Bid Addendum 05

Project: Maritime Museum Education Center,
Beaufort, NC – Construction Phase Services

Date: August 2, 2024

SCO#: 24-27956-01A

SHEET
INTERIOR ELEVATIONS

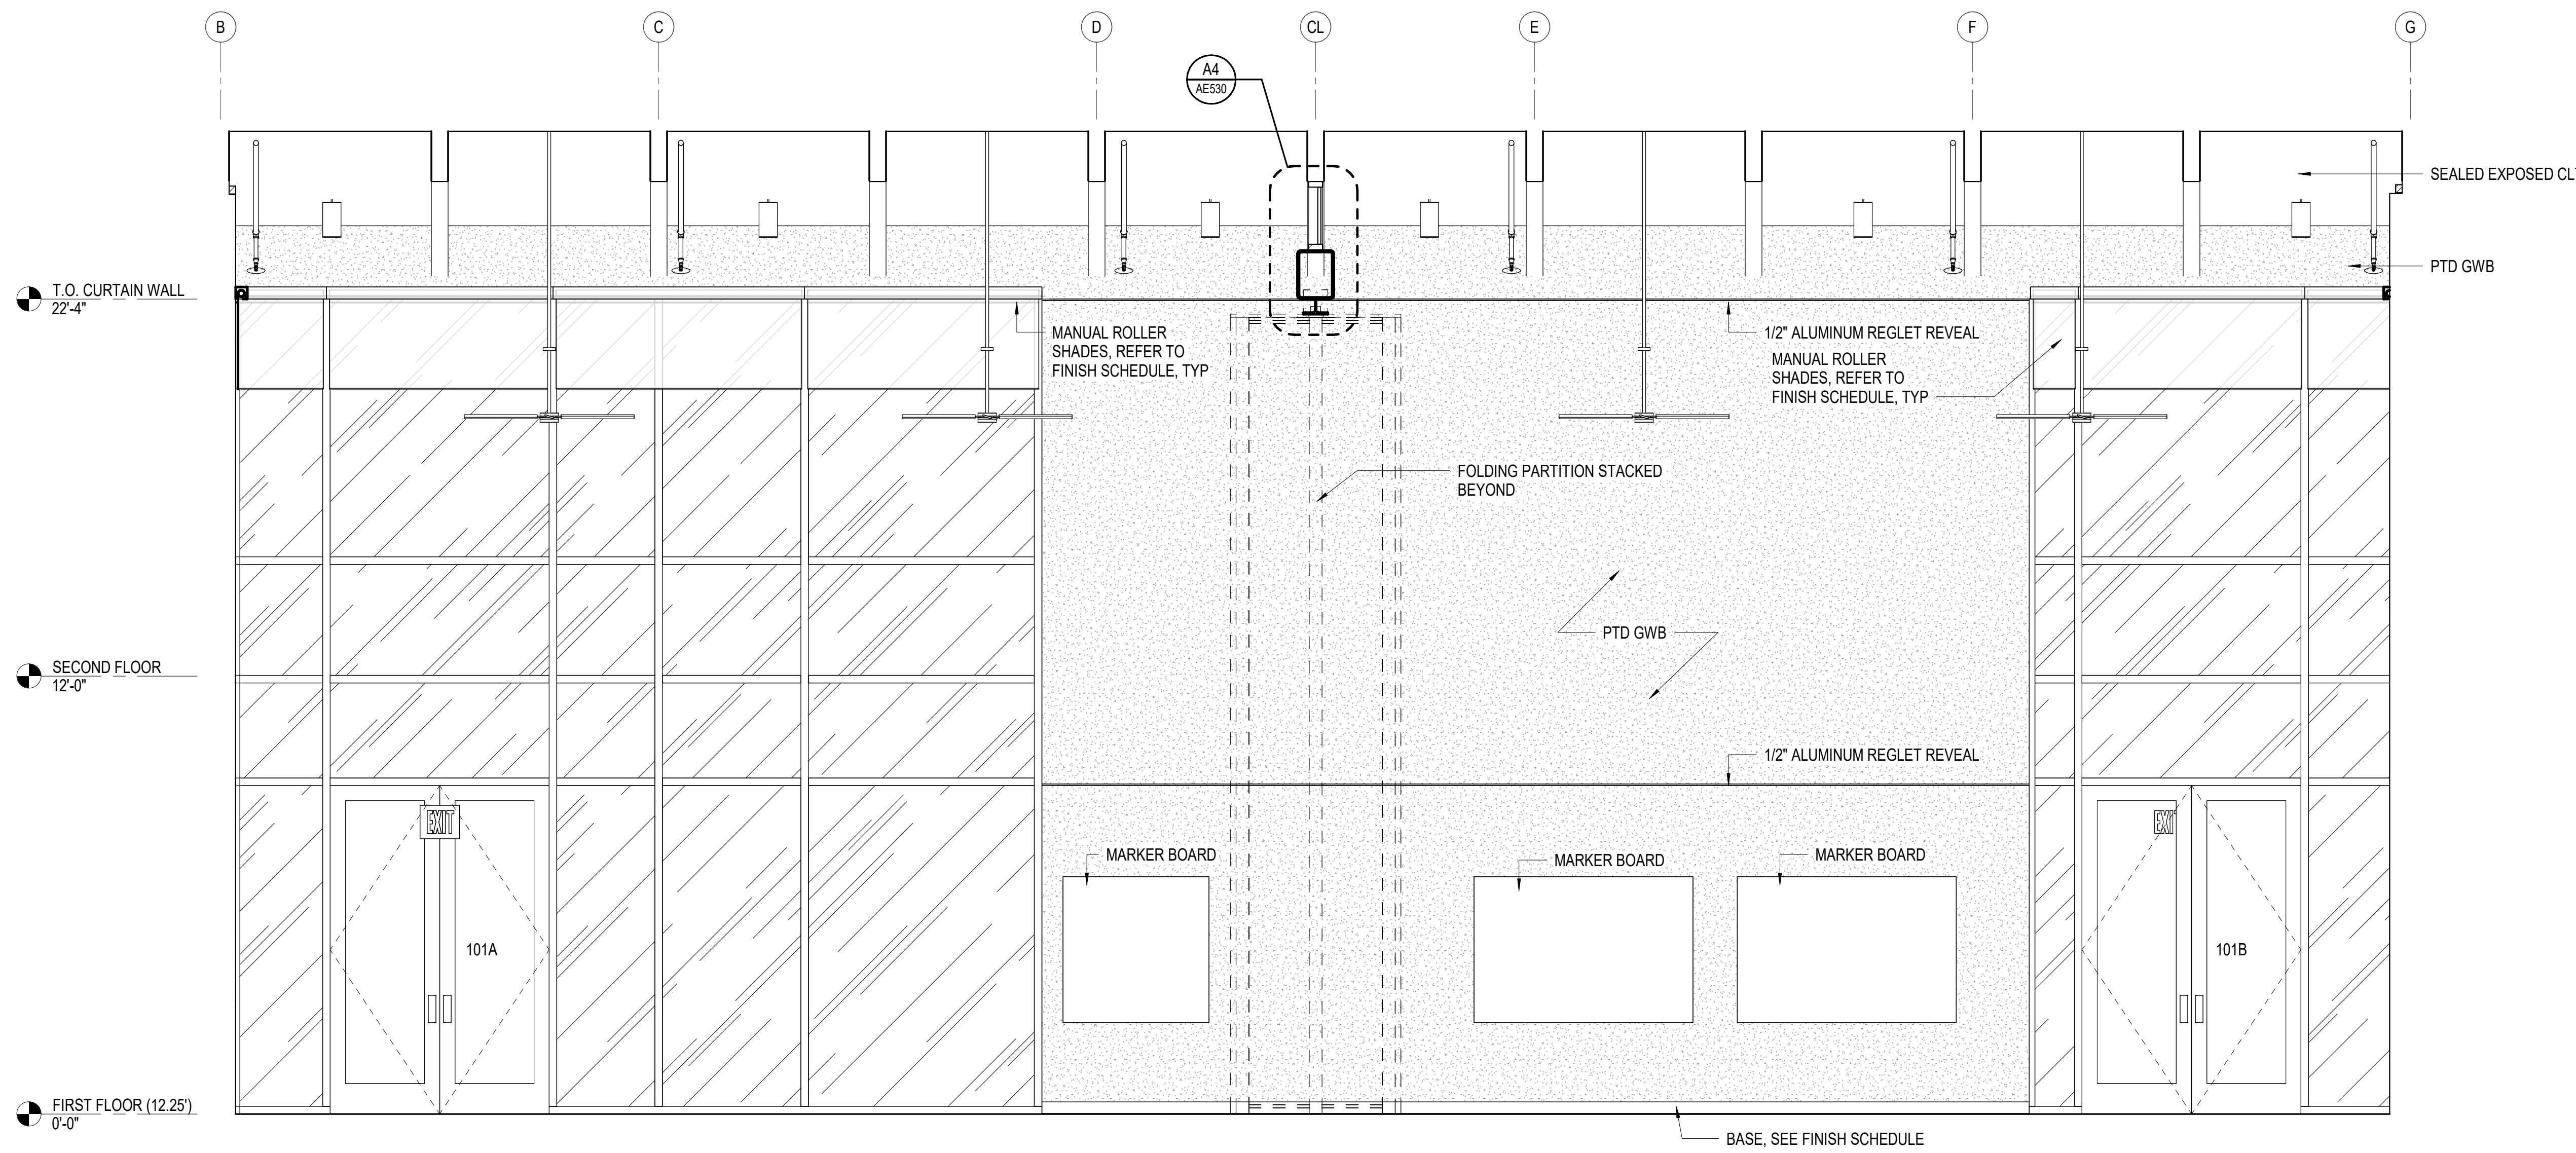
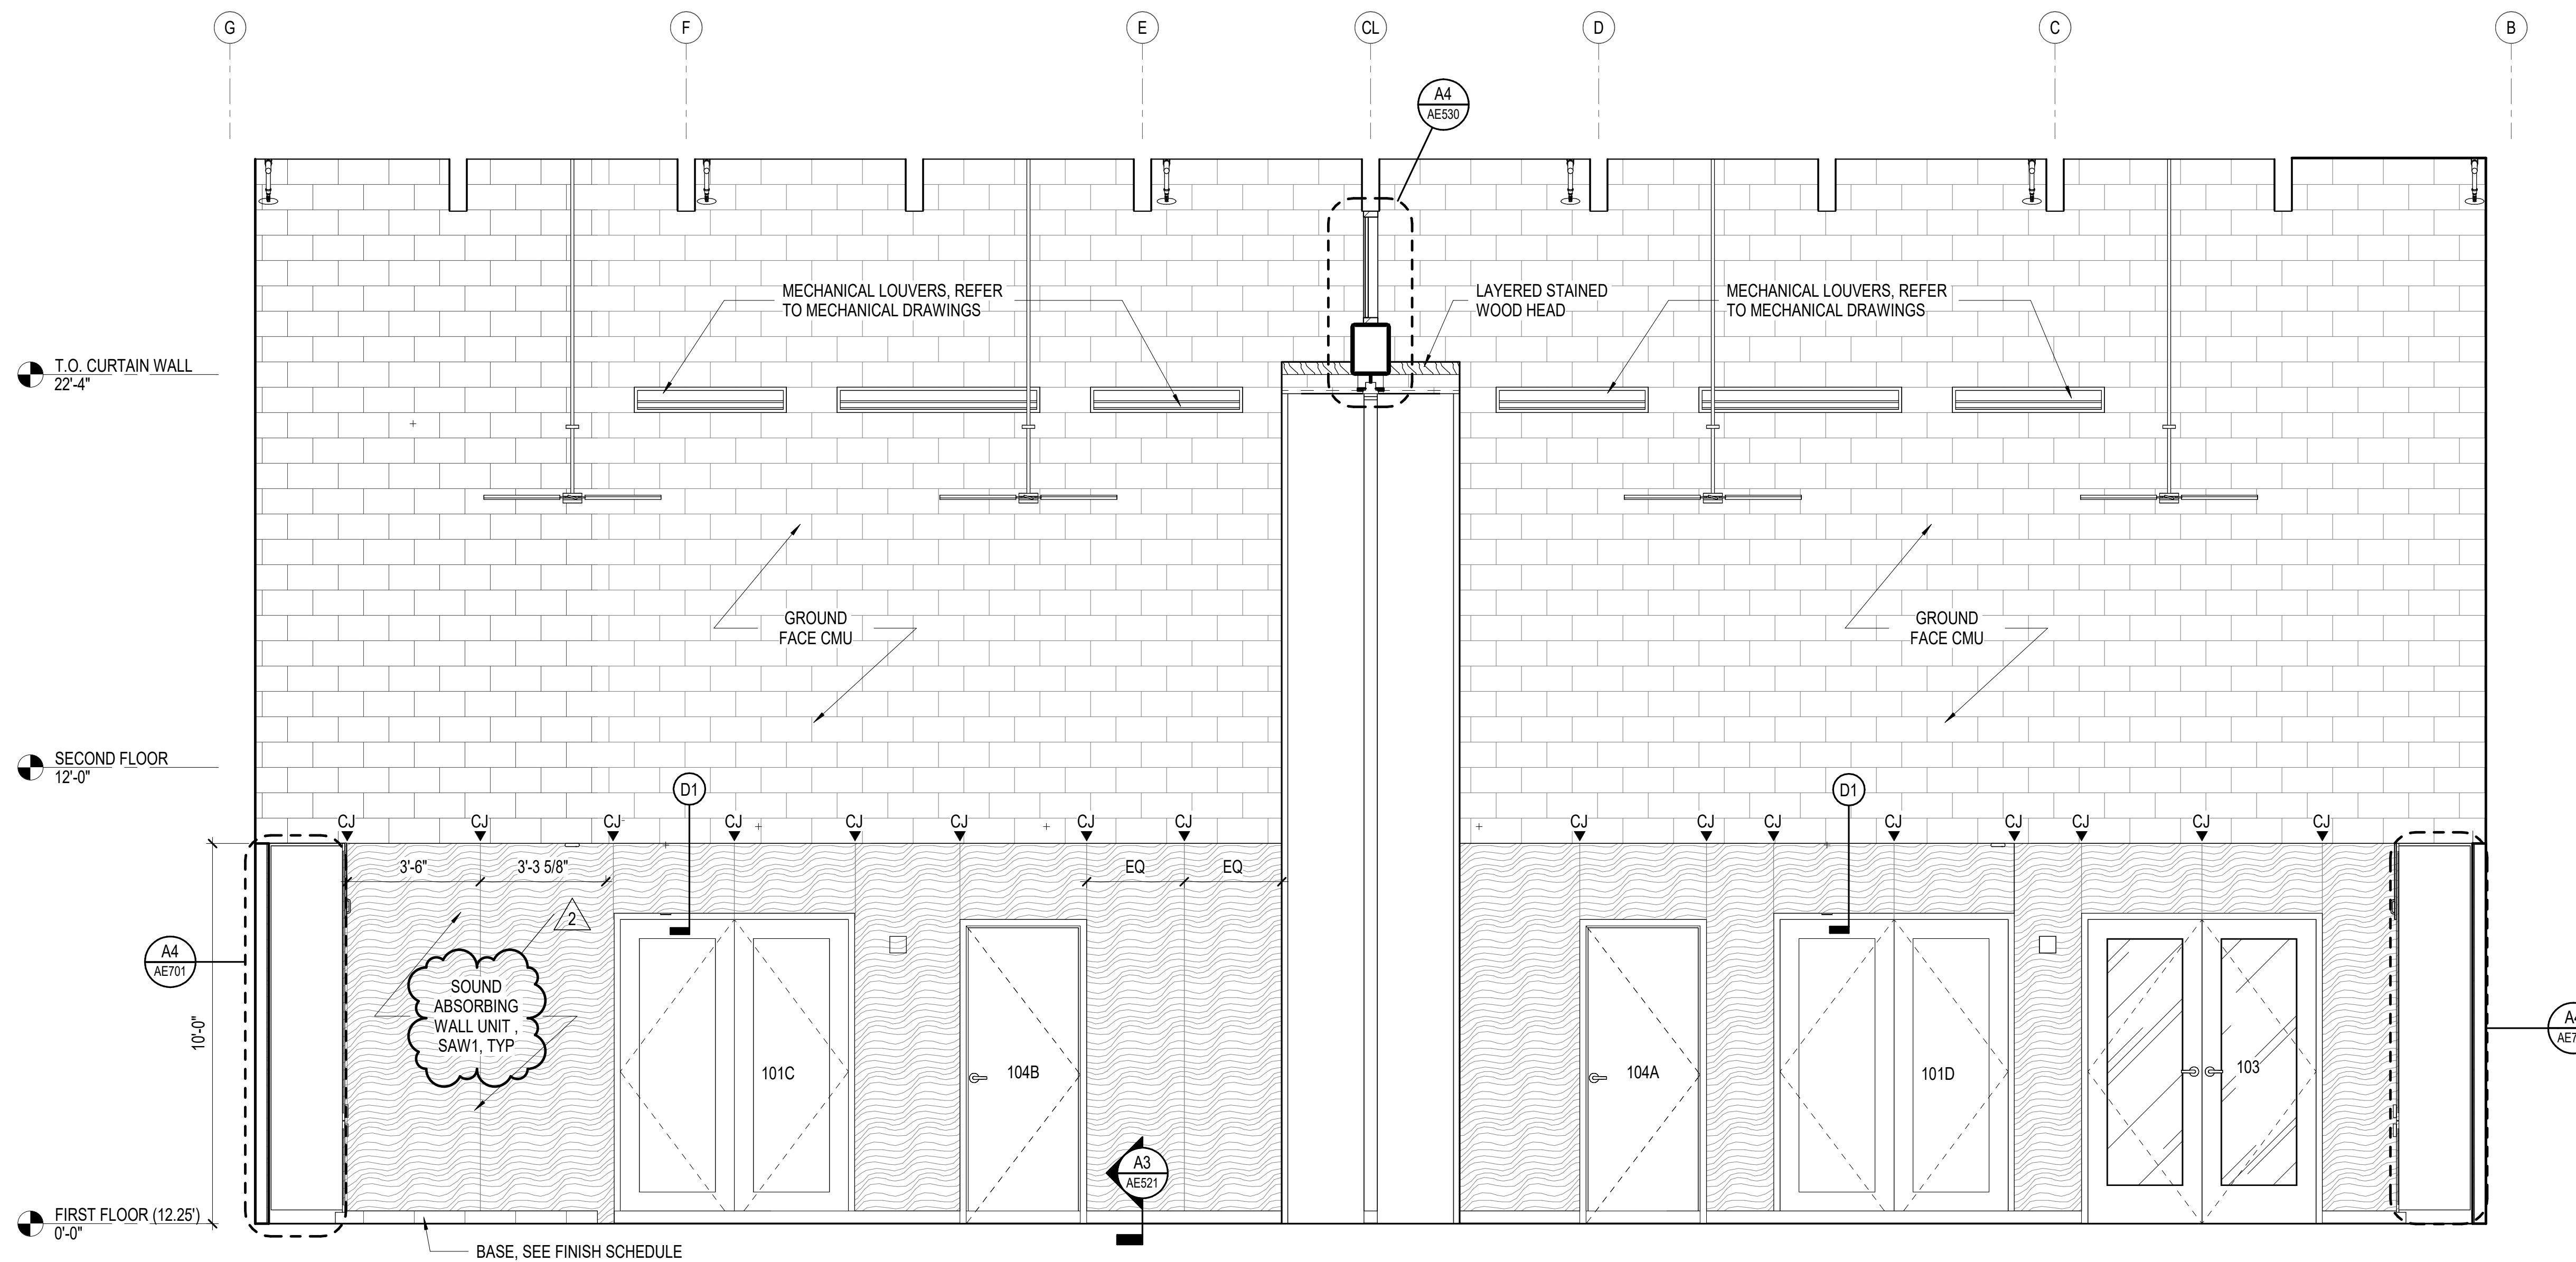
19. Sheet AE408
 - a. Sound Absorbing Wall callout has been added.
20. Sheet AE701
 - a. Sound Absorbing Wall callouts have been added.
21. Sheet IN101
 - a. SAW2 added to walls in room 101 as indicated.

FIRST FLOOR FINISH PLAN
SCALE: 1/8" = 1'-0"

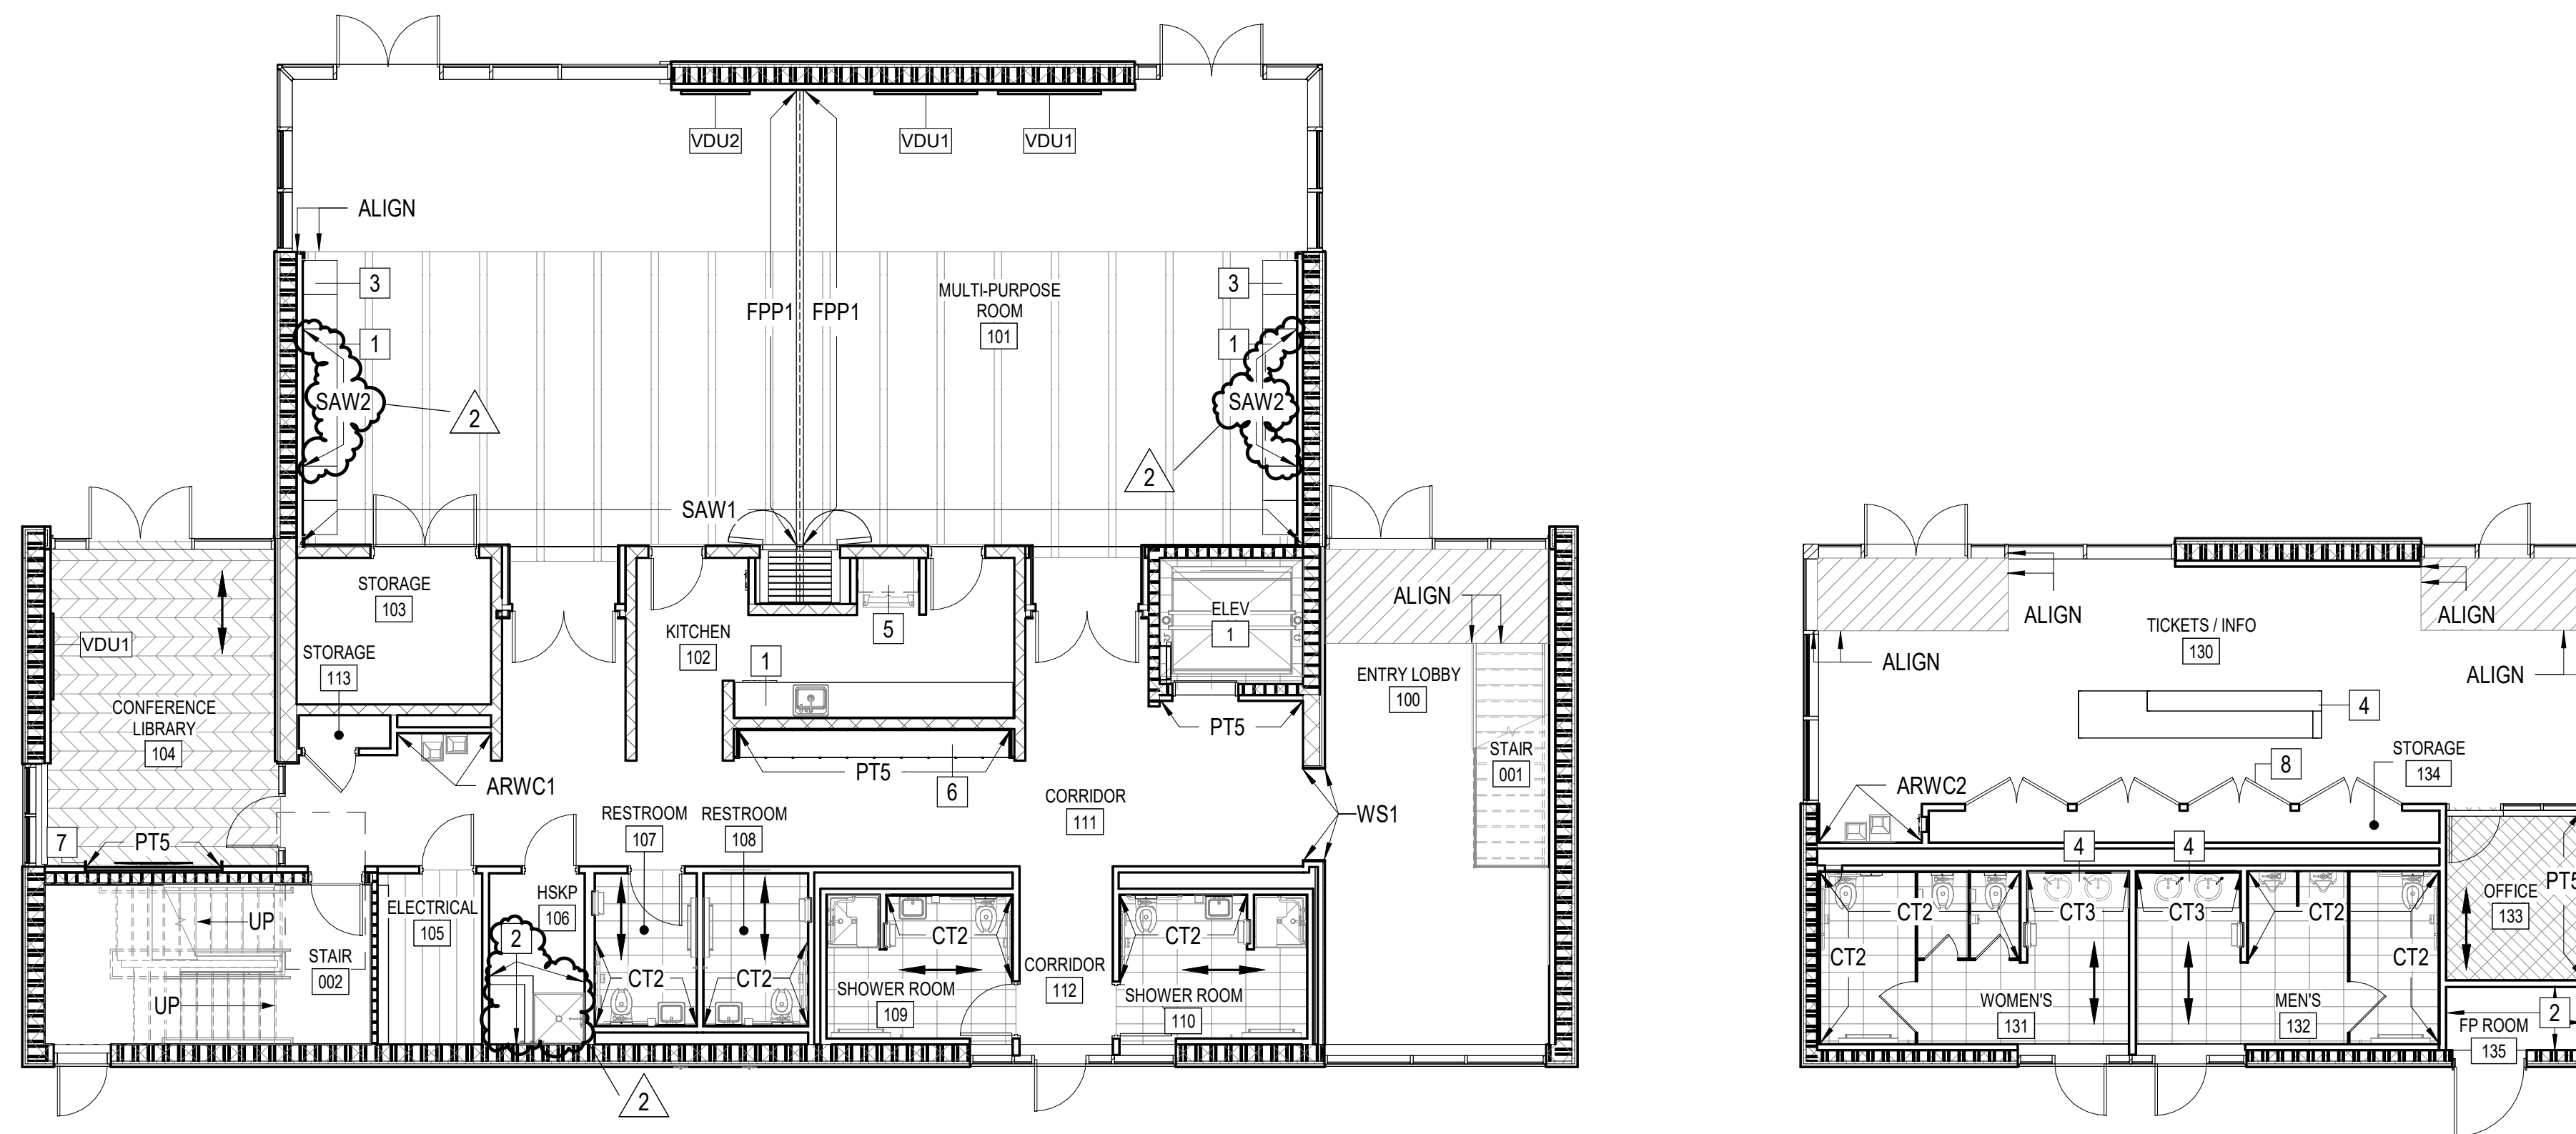
- b. Extents of abuse-resistant wallcovering have been modified in room 106.
 - c. Floor Finish Legend has been revised to include PCFT1
22. Sheet IN601

10. **QUESTION:** Please verify the following floor finishes. Room 100 has CPT2 pattern on Floor Plan (FP), but none listed on Finish Schedule (FS), Room 130 has CPT2 pattern on FP, but CPT3 on FS. Is the Floor Plan or Finish Schedule correct?
- a. **RESPONSE:** Refer to sheets IN101 and IN601. The Finish Schedule has been revised. Room 100 is to receive CPT2 and Room 130 is to receive CPT2.
11. **QUESTION:** On page PE001, the plumbing fixture schedule P-8 refers to a tile shower that is detailed on the architectural drawings. I cannot find any detail on the tile or type of tile. Please advise/direct.
- a. **RESPONSE:** Refer to sheets IN101 and IN601 and project manual for tile specifications and installation pattern.
